6.2 Containment Systems

The information in this section of the reference ABWR DCD, including all subsections, tables, and figures, as modified by the STP Nuclear Operating Company Application to Amend the Design Certification rule for the U.S. Advanced Boiling Water Reactor (ABWR), "ABWR STP Aircraft Impact Assessment (AIA) Amendment Revision 3," dated September 23, 2010 is incorporated by reference with the following departures and supplements.

STD DEP 6.2-2 (Tables 6.2-1 and 6.2-2, Figures 6.2-2, 6.2-3, 6.2-4, 6.2-5, 6.2-6a and b, 6.2-7a and b, 6.2-8a, 6.2-8b, 6.2-8c, 6.2-9, 6.2-10, 6.2-11, 6.2-12a and 6.2-12b, 6.2-13a and 6.2-13b, 6.2-14, 6.2-15, 6.2-22, 6.2-23a, 6.2-23b, 6.2-24, 6.2-25a, and 6.2-25b.)

Figure 6.2-3 Feedwater Line Break Flow—Feedwater System Side of Break

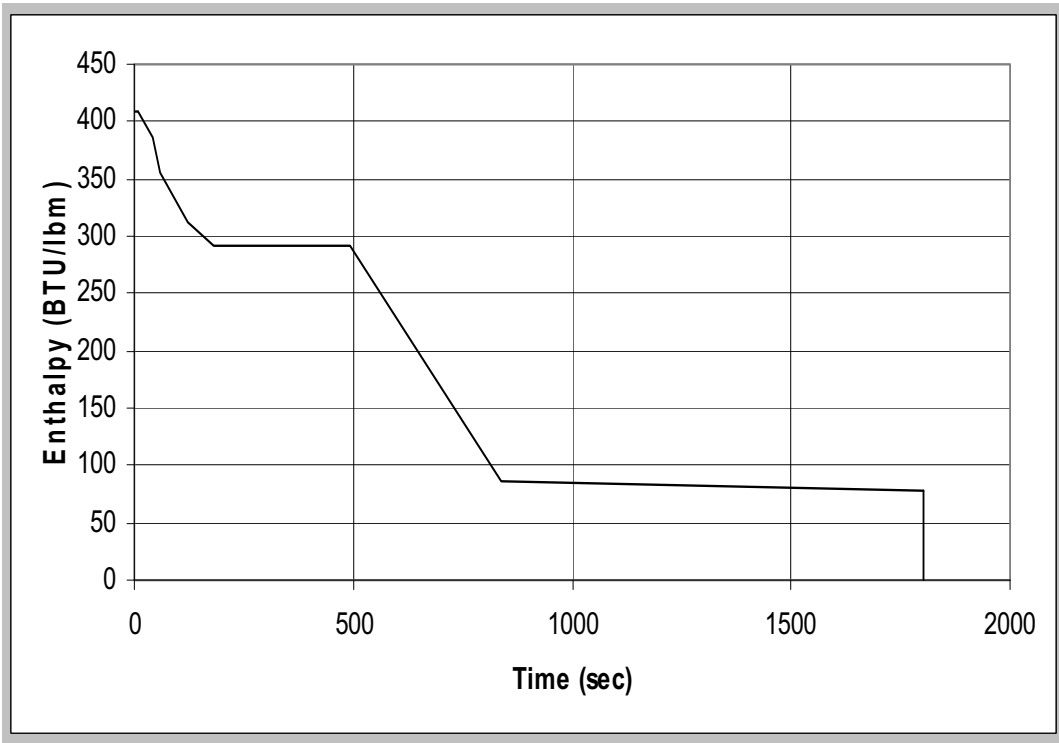
~~The maximum possible feedwater flow rate was calculated to be 164% of nuclear boiler rated (NBR), based on the response of the feedwater pumps to an instantaneous loss of discharge pressure. Since the Feedwater Control System will respond to decreasing RPV water level by demanding increased feedwater flow, and there is no FWLB sensor in the design, this maximum feedwater flow was conservatively assumed to continue for 120 seconds (Figure 6.2-3). This is very conservative because:~~

In order to provide further assurance of conservatism, FWLB mitigation is added to the ABWR design. The system is described in Section 7.3.1.1.2. The specific enthalpy time history, assuming the break flow of Figure 6.2-3, is shown in Figure 6.2-4. Initial reactor power is assumed to be 102% NBR.

Figure 6.2-6a Drywell Pressure Response for Feedwater Line Break

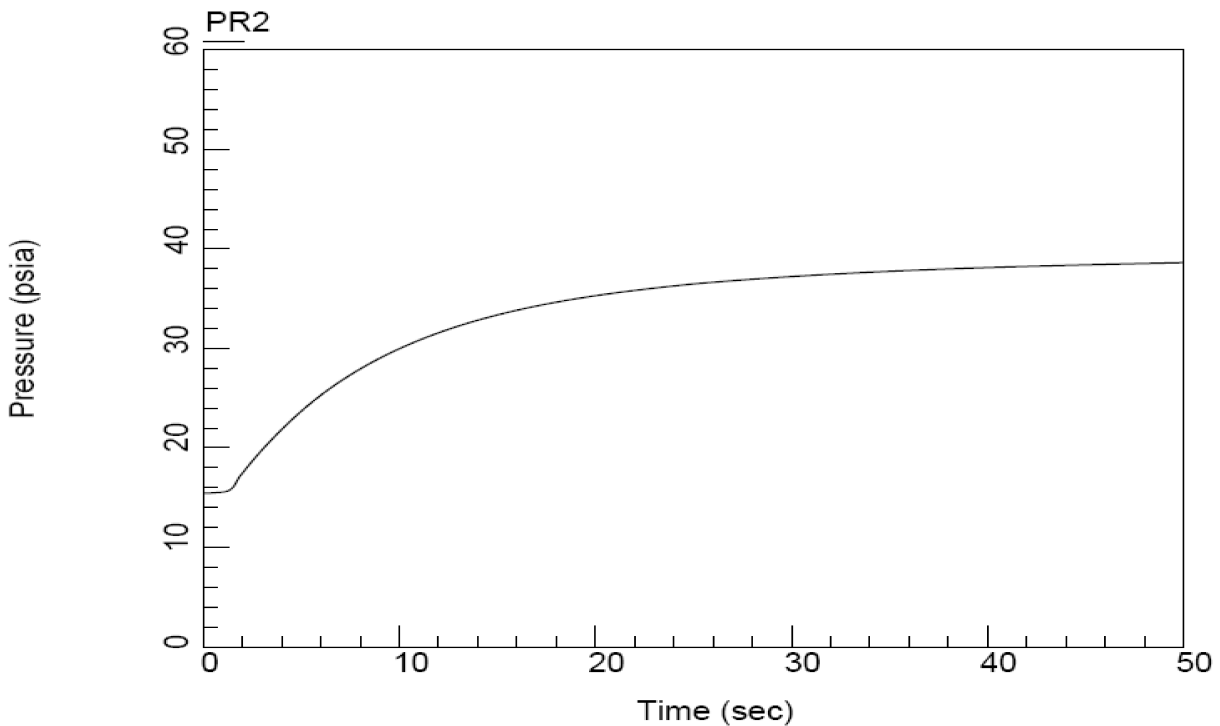
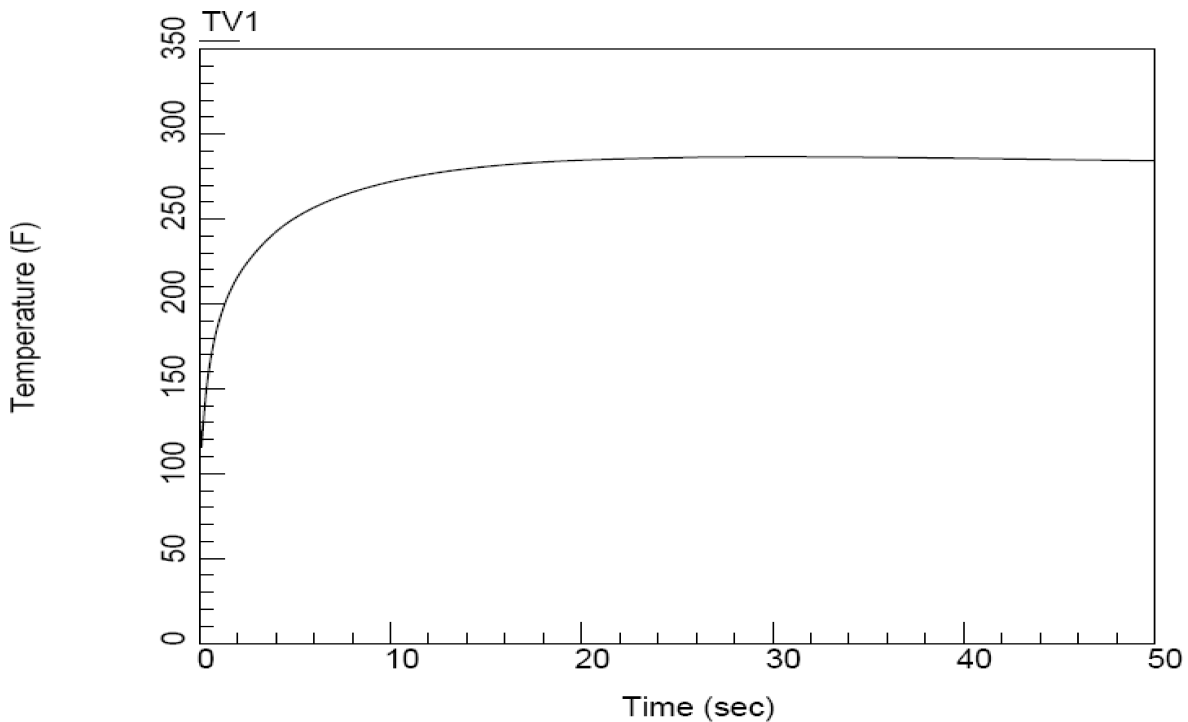
~~The calculated containment pressure and temperature responses for a feedwater line break are shown in Figures 6.2-6 and 6.2-7, respectively. The peak pressure (268.7 kPaG) and temperature (140°C) occur in the drywell. The containment design pressure of 309.9 kPaG is 115% of the peak pressure.~~

The short term pressure peak (268.7 kPaG) of Figure 6.2-6 is the peak pressure for the whole transient. Figure 6.2-8 shows temperature time histories for the suppression pool, wetwell, and drywell temperatures. The peak pool temperature (99.6°C) is reached at 6600 seconds (1.833 hours). This is less than the suppression pool temperature value of 100°C which is used in the net positive suction head available (NPSHA) calculations for RHR and HPCF.

The maximum drywell pressure occurs in the case of a feedwater line break (~~268.7~~281.8 kPaG). The design pressure for the drywell (309.9 kPaG) includes 16%approximately 10% margin.

Figure 6.2-9 ABWR Main Steamlines with a Break

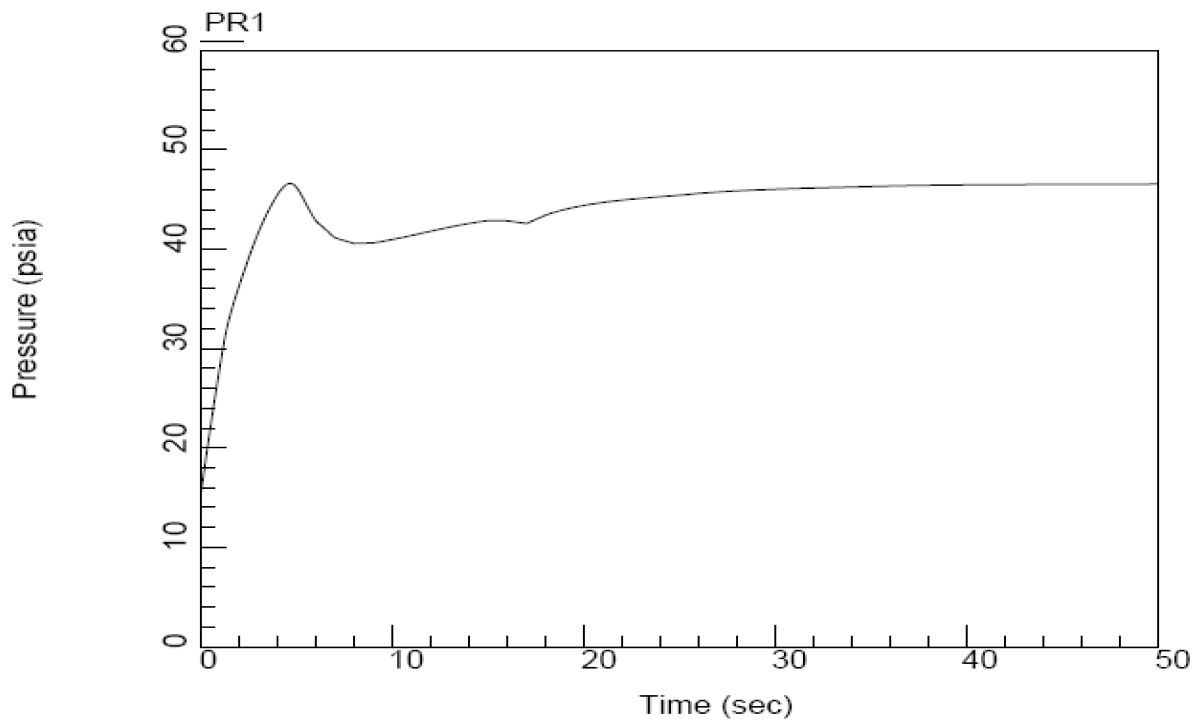
A schematic of the ABWR main steamlines, with a postulated break in one of the main steamlines, is shown in Figure 6.2-9. The main steamline (MSL) break is a double-ended break with one end fed by the RPV directly through the broken line, and the other fed by the RPV through the unbroken main steamlines until the MSIVs are closed. Once the MSIVs are closed, the break flow is only from the RPV through the broken line.

Each MSL contains a flow limiter built into the MSL nozzle on the RPV with a throat area of 0.09848 m², as shown in Figure 6.2-9. This flow limiter provides the effective break area for the vessel side.

- (1) Each MSL contains a flow limiter built into the MSL nozzle on the RPV with a throat area of 0.0983m², as shown in Figure 6.2-9.*
- (2) The break is located in one MSL at the inboard MSIV.*
- (3) During the inventory depletion period, the flow multiplier of 0.75 is applied (Reference 6.2-1).*
- (4) The flow resistance of open MSIVs is considered. A conservative value of 2.062 for pressure loss coefficient for two open MSIVs was taken. The nominal value is approximately 3.0. When the open MSIV resistance is considered, the flow chokes at the MSIV on the piping side as soon as the inventory depletion period ends. The effective flow area on the piping side reduces to 70% of a frictionless piping area. The value of 70% applies to flow of steam and twophase mixture with greater than 15% quality.*

Figure 6.2-12a Drywell Pressure Time History for MSLB

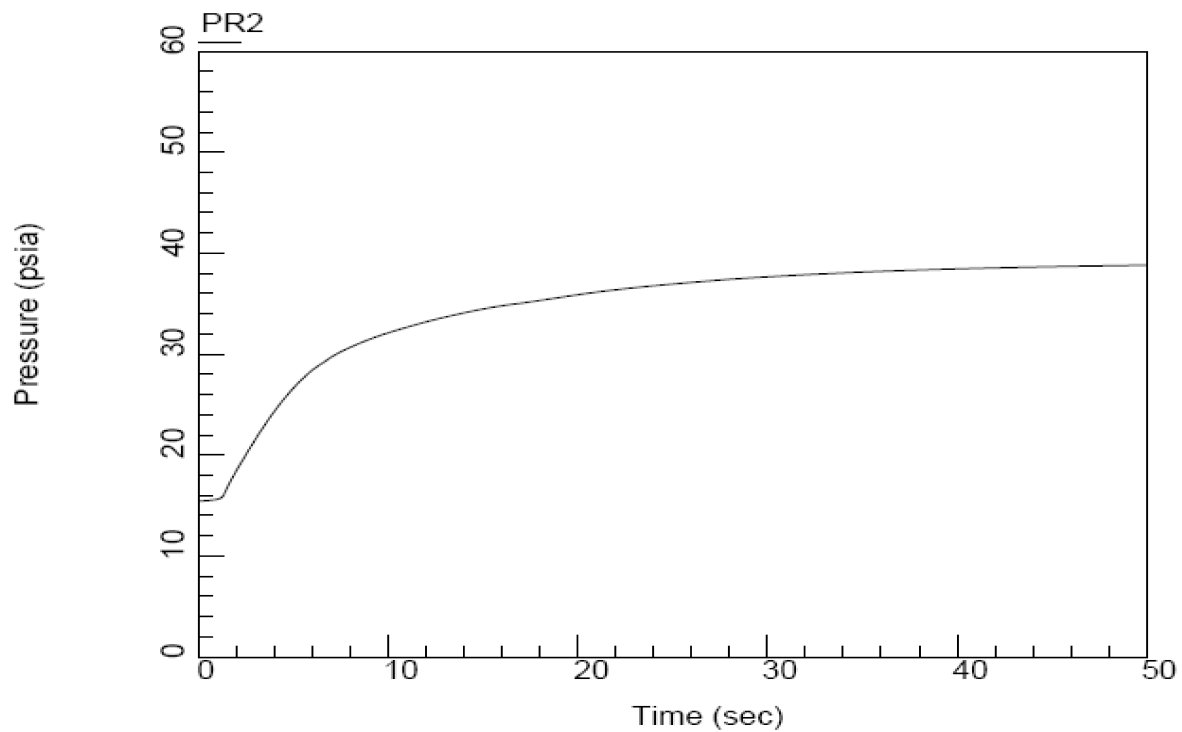
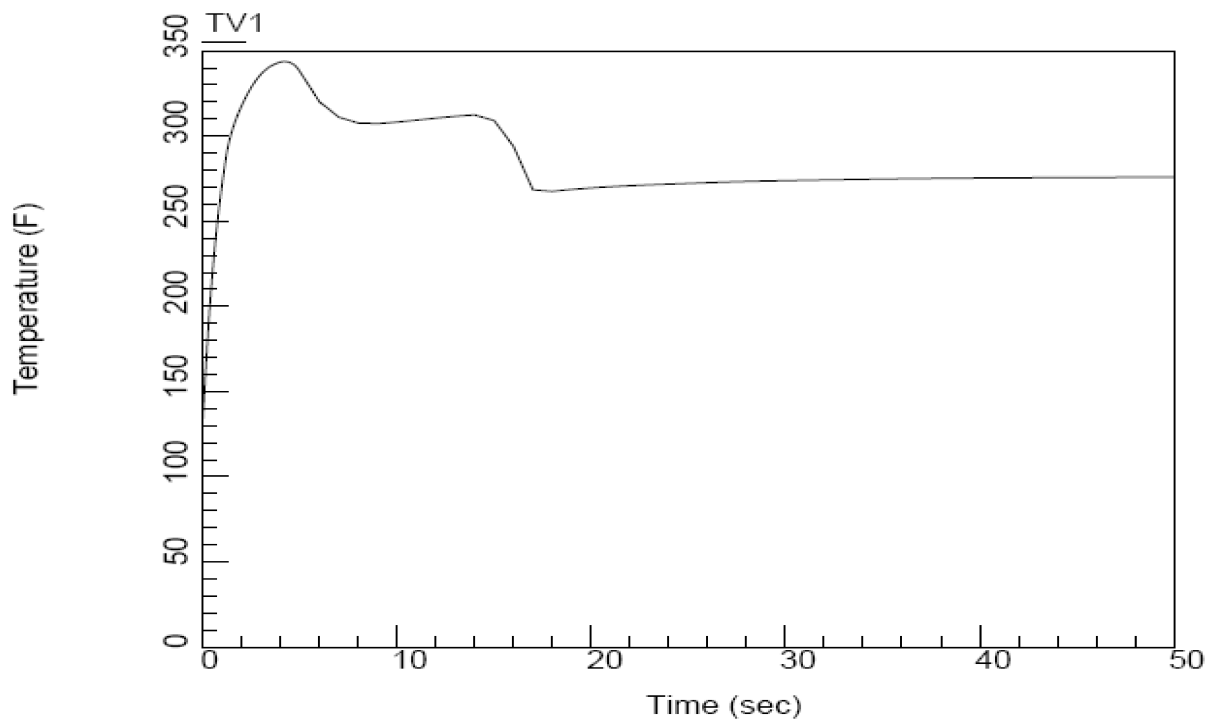
Figures 6.2-12 through 6.2-15 and 6.2-13 show the pressure and temperature responses of the drywell and wetwell during the blowdown phase of the steamline break accident.

Figure 6.2-13a Drywell Temperature Time History for MSLB

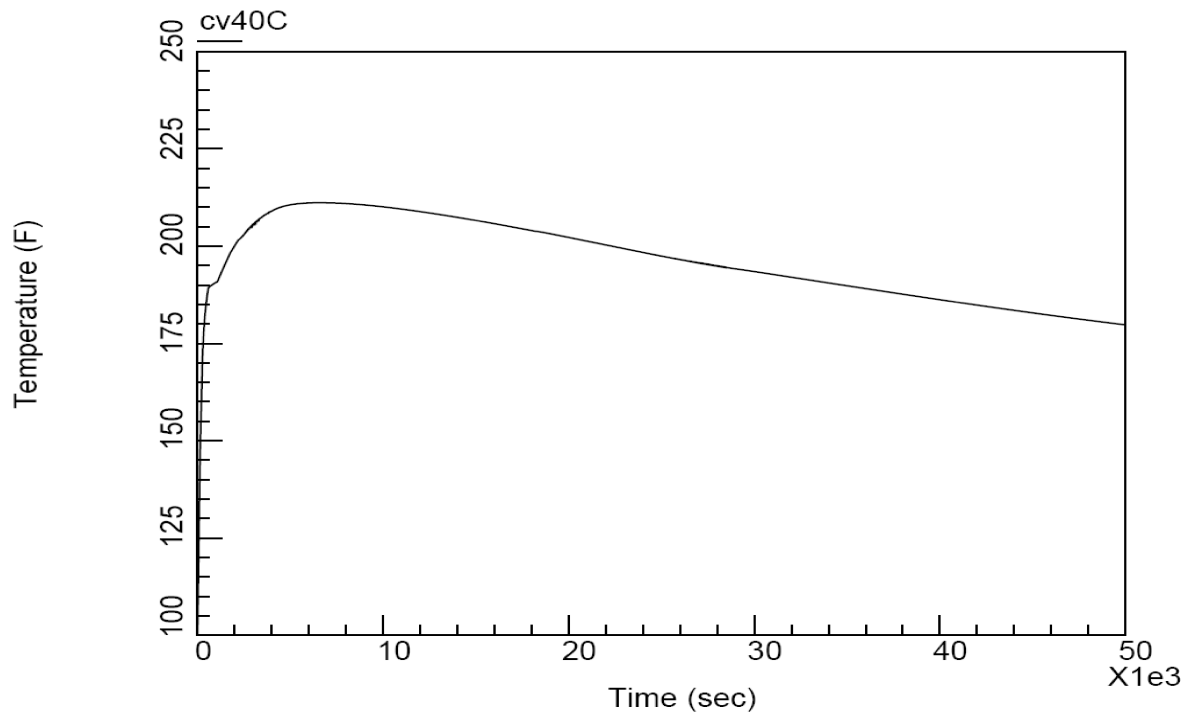
~~The long term containment pressure and temperature responses following the MSLB accident remain below those for the feedwater line break, which is the most limiting event.~~ The long-term containment pressure response following the MSLB accident remains below that for the feedwater line break. The long-term temperature response remains below that for the peak achieved in the short term for the steam line break shown in Figure 6.2-13.

The maximum drywell temperature occurs in the case of a steamline break (~~469.7°C~~173.2°C). Although this exceeds the ABWR drywell design temperature (171.1°C), it only exceeds it by 2.1°C and only for about 2 seconds. Due to thermal inertia, components in the drywell would not have sufficient time to reach the design limit temperature. and is below the design value (171.1°C).
